ADDENDUM NO. 1

US19 RECLAIMED WATER TRANSMISSION SYSTEM - PHASE I

IN
HERNANDO COUNTY, FLORIDA
SOLICITATION NO. 18-CG0042/BH
BID DATE: FEBRUARY 14, 2018

WATER: AIR/VACUUM RELEASE VALVE DETAIL
SCALE: NONE

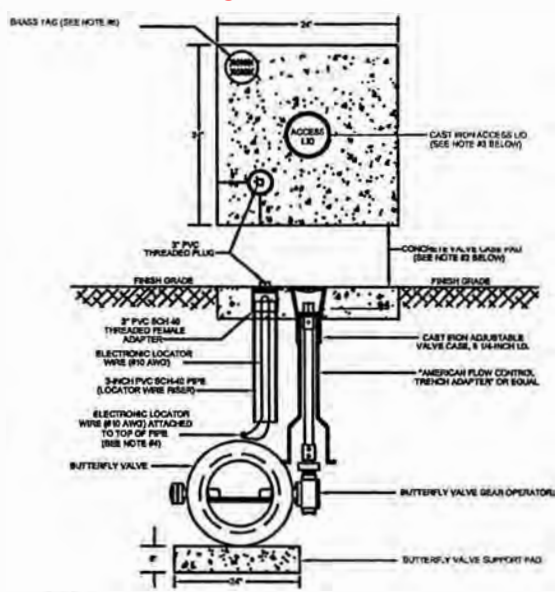
1. Replace Exhibit C – UTILITY DETAILS (2), sheet No. D-101 from the Bid Document with Attachment A – UTILITY DETAILS (2), sheet No. D-101 located herein for all bidding purposes. Revision: The ARV detail on sheet D-101 needs to have the color Blue changed to Purple in regards to the 2" PET.

3. Question: We also had questions regarding the ARV's on this job. When looking at the plans and comparing to the Bid Form quantities some concerns were raised. On 11 of the ARV's they call for an Above Ground ARV, but when looking at the actual drawing they are drawn as an offset below ground. We are really just looking to confirm exactly which ARV's are required on this job in the locations where it is drawn with what appears to be a tee, but is called as an above ground which would us a saddle. The Stations included but may not be limited to: C-102, STA 878+90; C-104, STA 910+50; 115, STA 1034+55; 1043+00; C-118, STA 1071+45; C-120, STA 27+50; C-122, STA 1+30; C-123, STA11+20; C-124, STA 9+00; C-115, STA 1034+55; 1043+01.

Answer: The ARV symbol used on the plans is just a symbol. Refer to the call out for the symbol to determine if the ARV is an above ground or below ground ARV. The ARV's that are called out as above ground, which are also offset installations, will use the detail on sheet D-101. The ARV's that are called out as below ground are also in-line installations and will use the detail on sheet D-100 for in-line ARV installations. Note: There is an error with the above ground detail on sheet D-101. The 2" poly tubing (PET) is called out as Blue and it should be Purple for reclaimed water use. See Attachment A for the revised sheet D-101 located herein.
